<b>BRIEF DESCRIPTION OF REQUEST</b>
Amend approved Site Plan for Building Permit to add in a retail kiosk.

**ADMINISTRATIVE AMENDMENT TO OVERALL SITE PLAN FOR BUILDING PERMIT**

## Administrative Amendment Request

Transportation Development Comments:

PROJECT TITLE MARKET 1861 3700 ELLISON DR NW ALBUQUERQUE, NT 87114	DRAWN BY: CDC
PROJECT MANAGER STEPHEN DUNBAR, AIA	JOB NO. ..
SHEET TITLE EXTERIOR ELEVATIONS	
DATE 01/19/2012	Sheet A-2
SCALE AS NOTED	et.

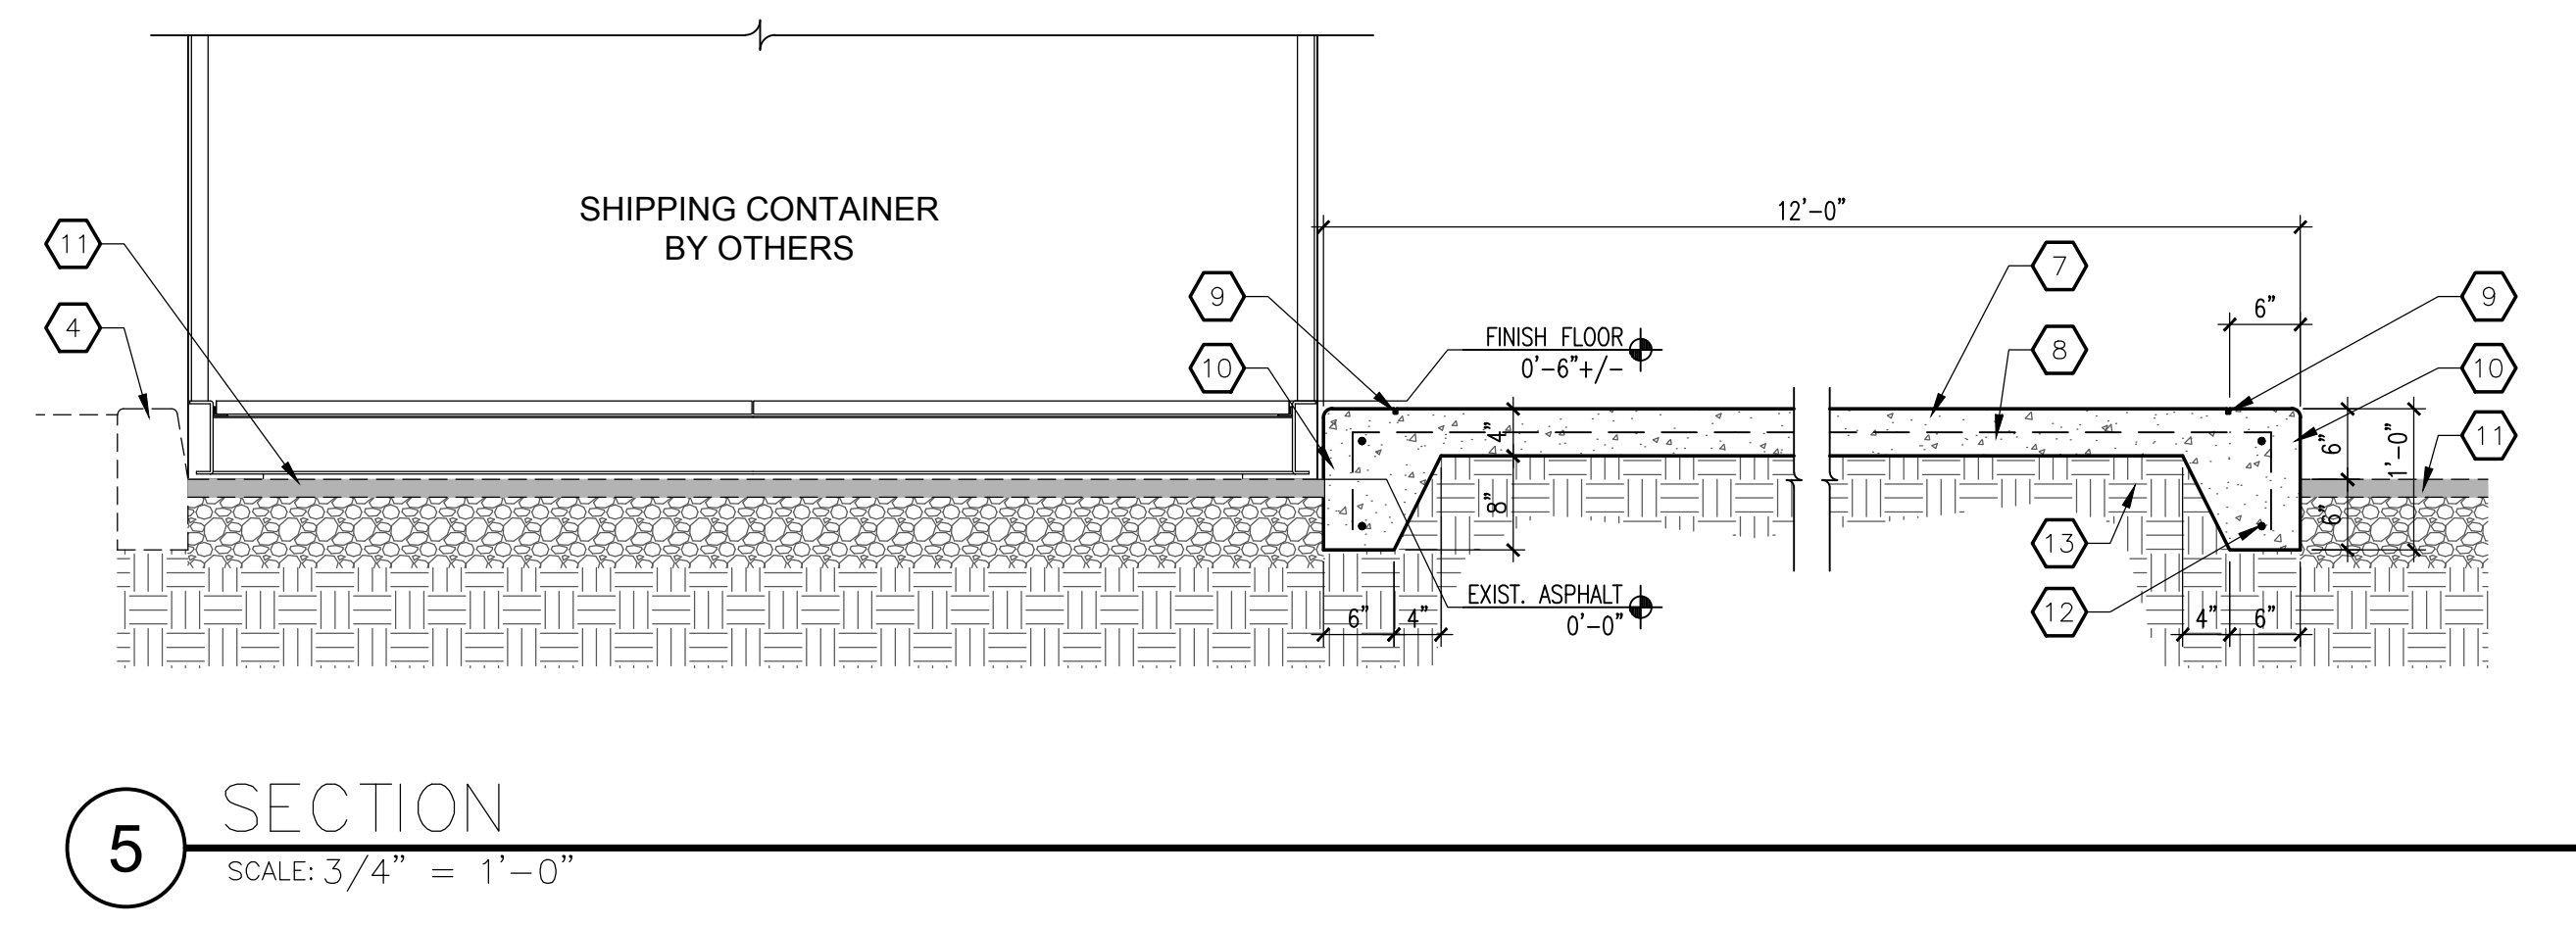
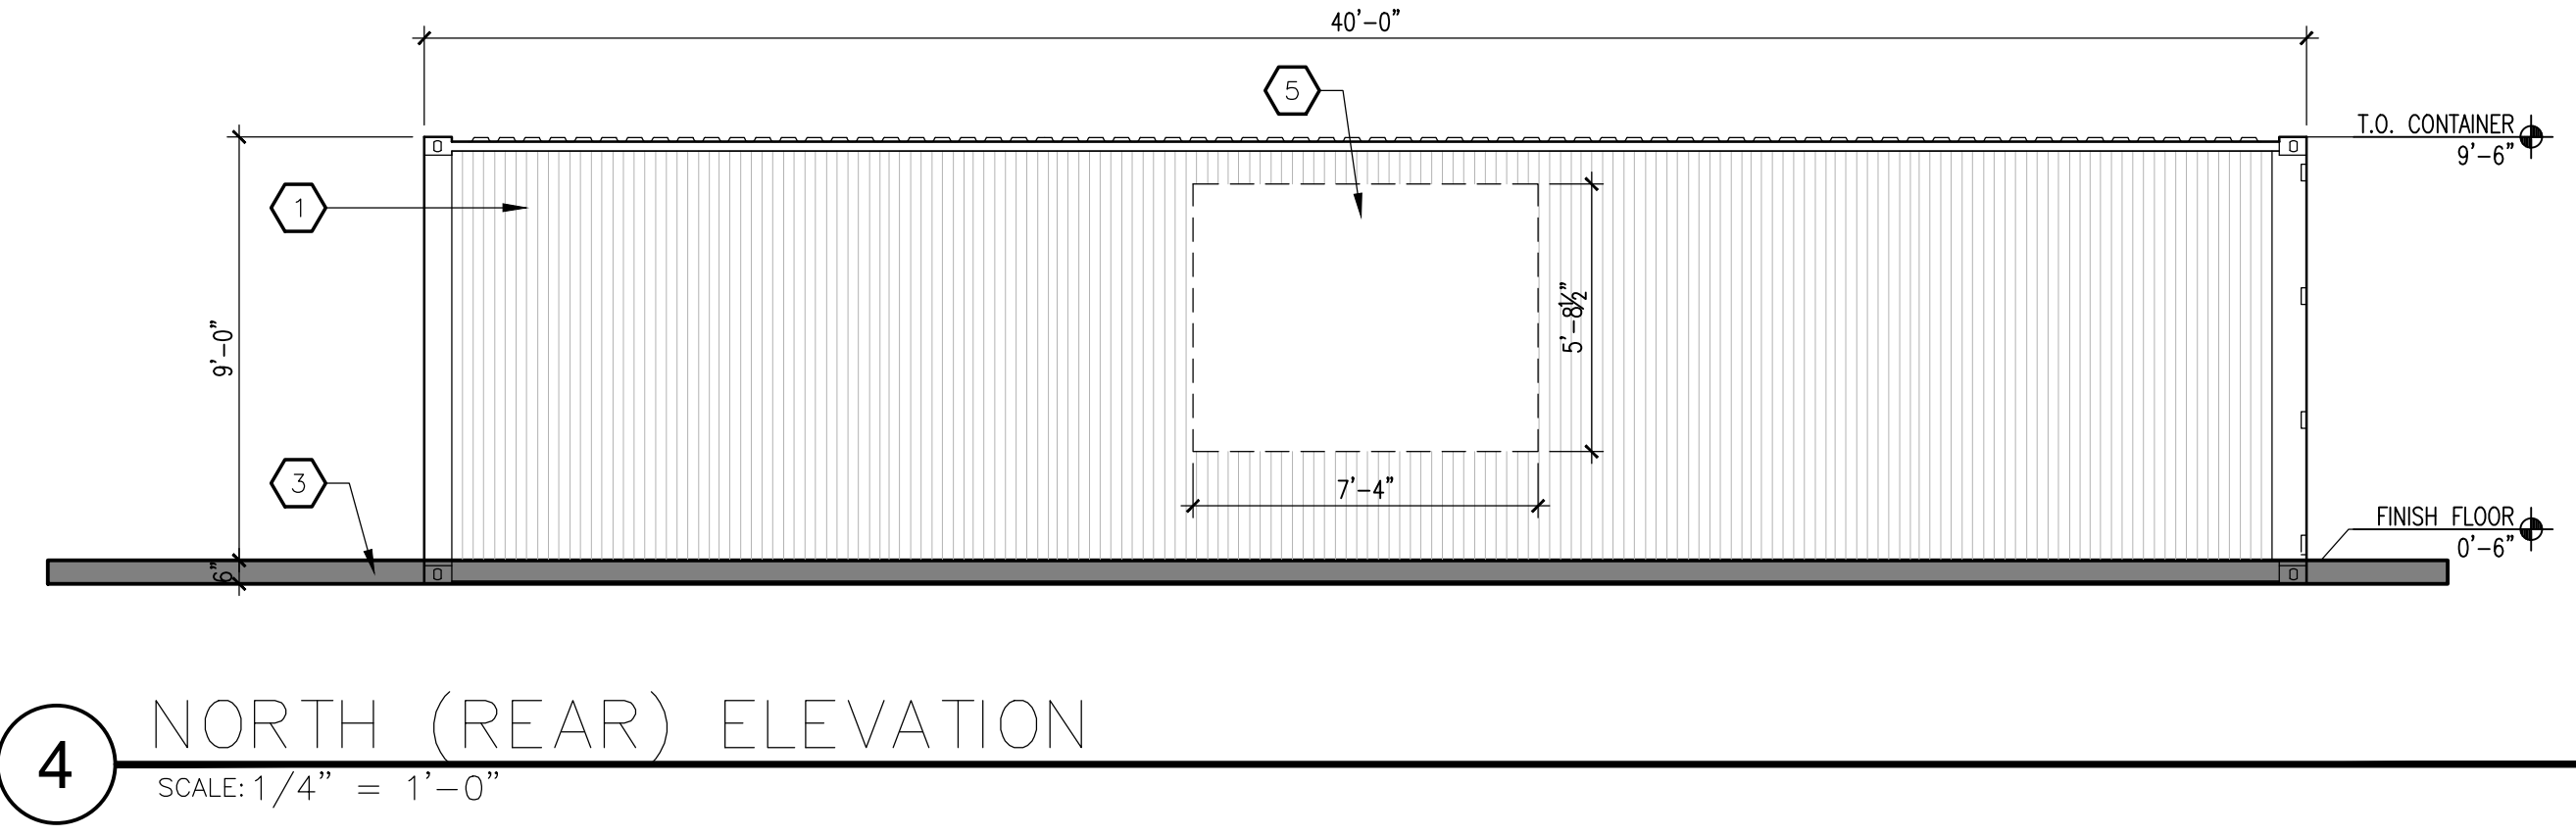
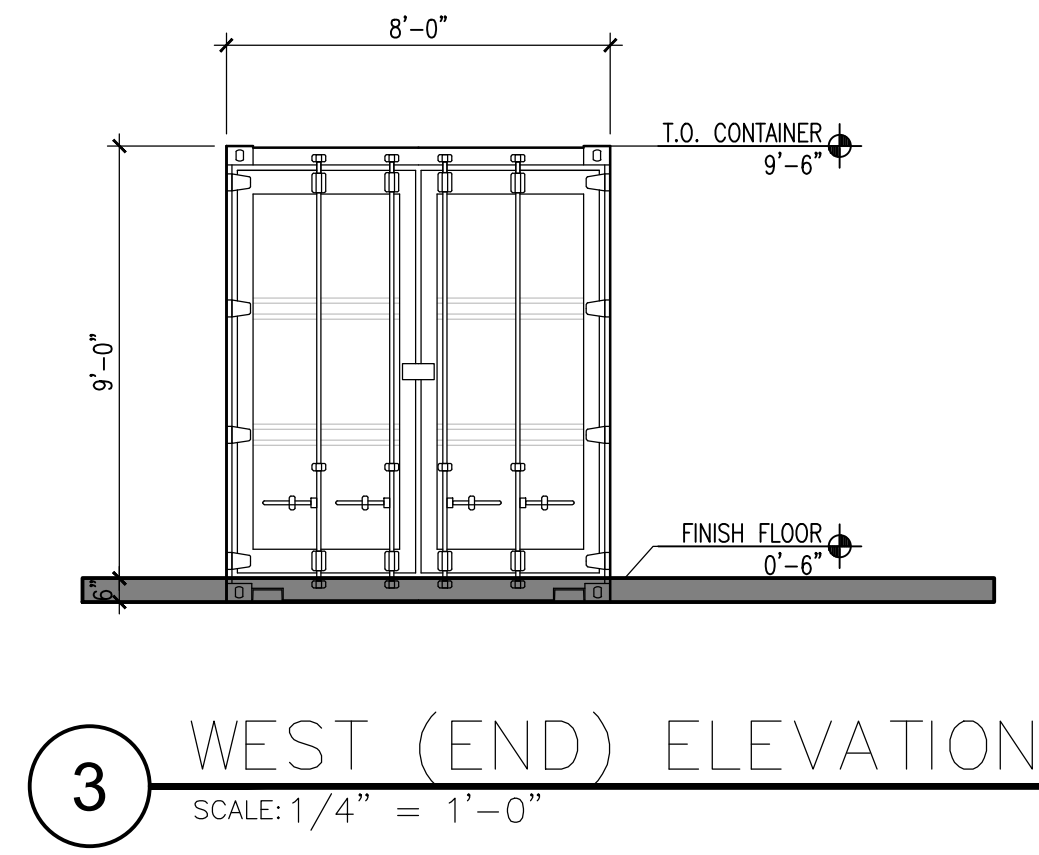
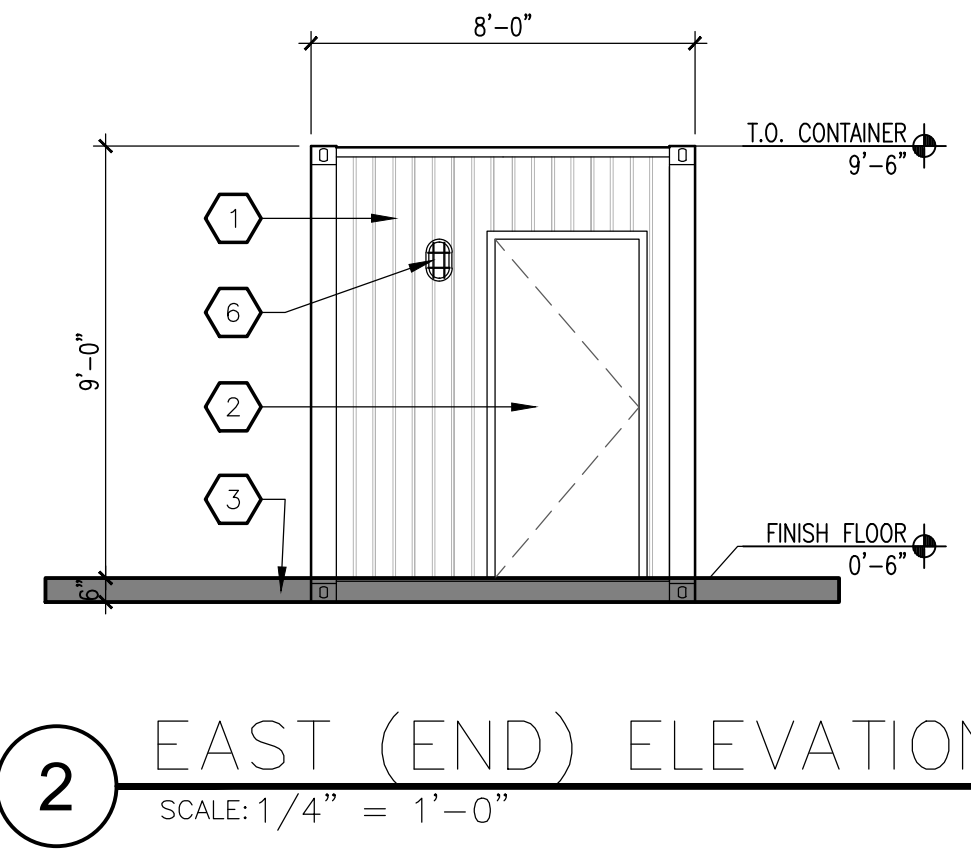
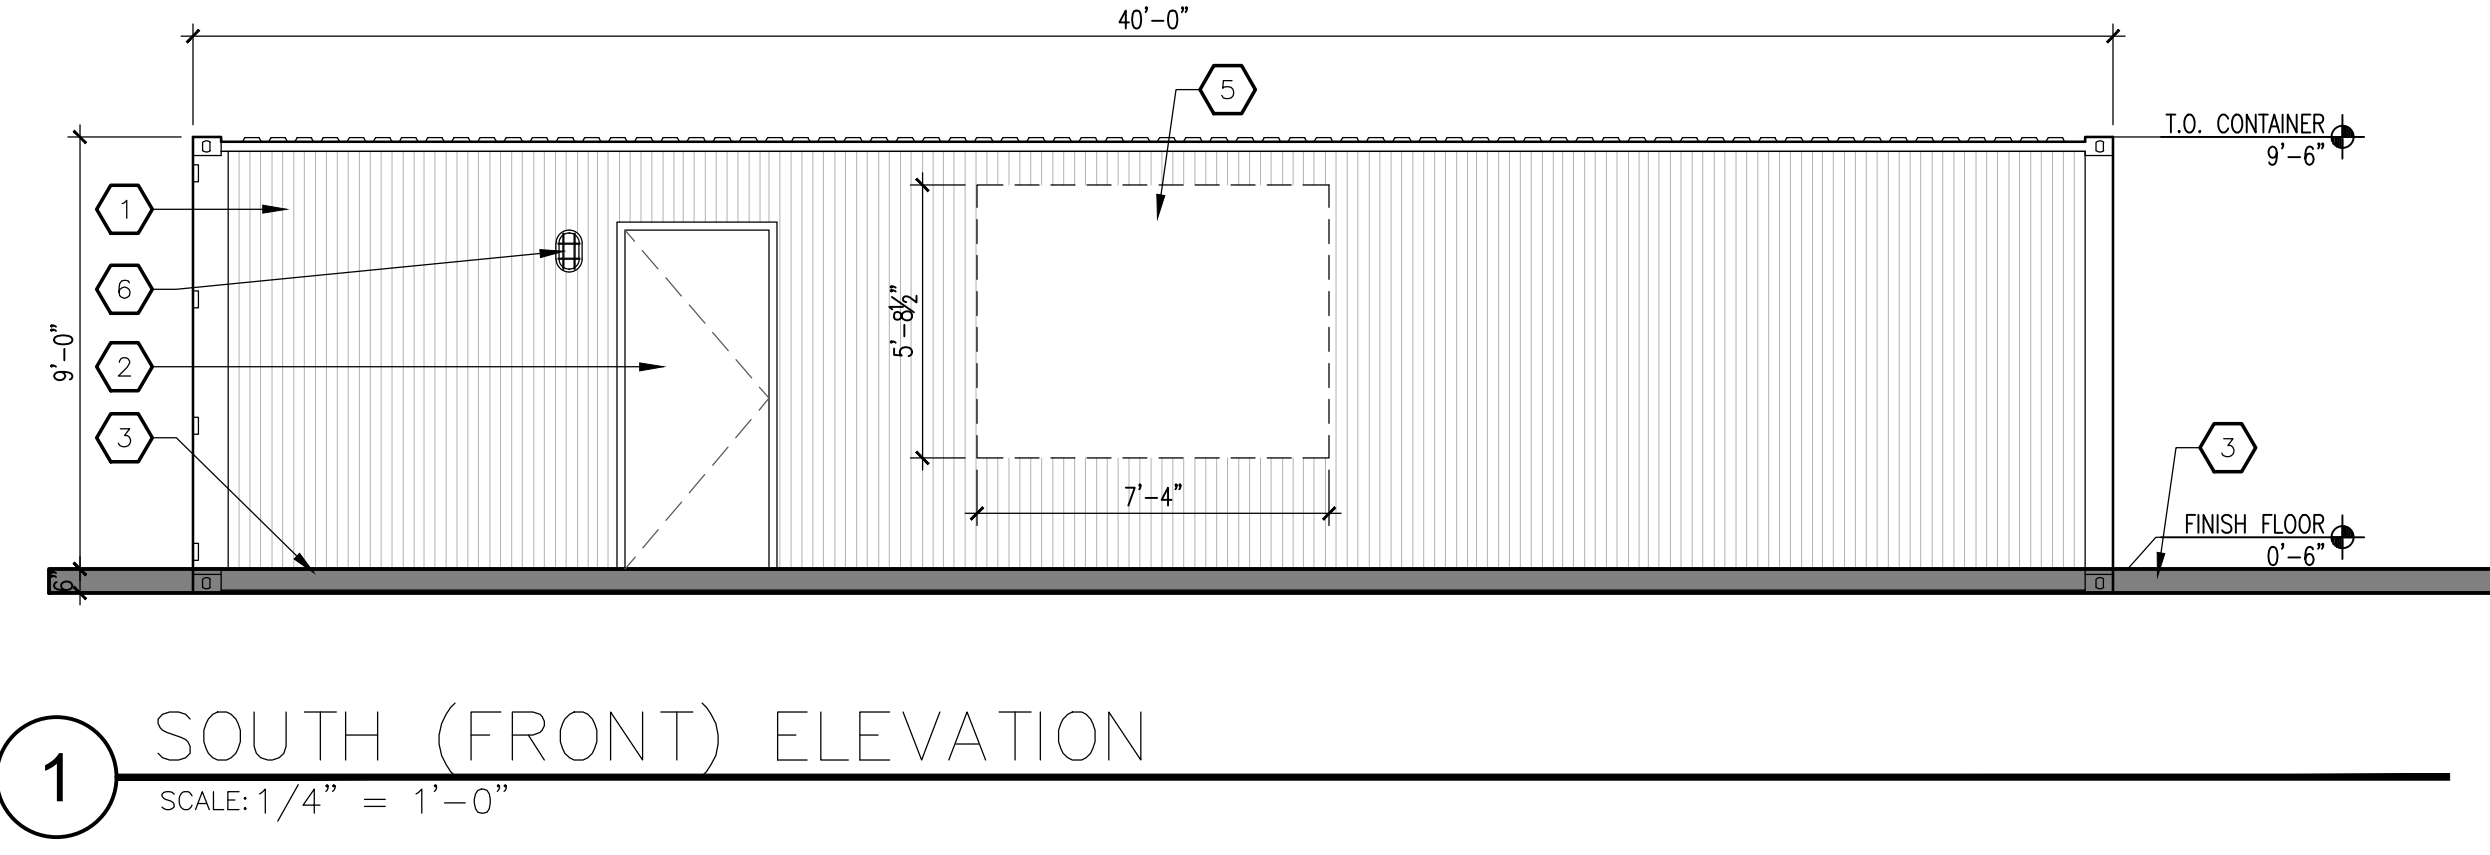
- Please explain why you are proposing concrete stoop and concrete landing.
  - Addressed:
    - The concrete around the kiosk is used to level the asphalt with the kiosk. The kiosk does not fit level on the asphalt.
- Provide details for the proposed concrete landing and concrete stoop.
  - Addressed:
    - Please see details on A-2.
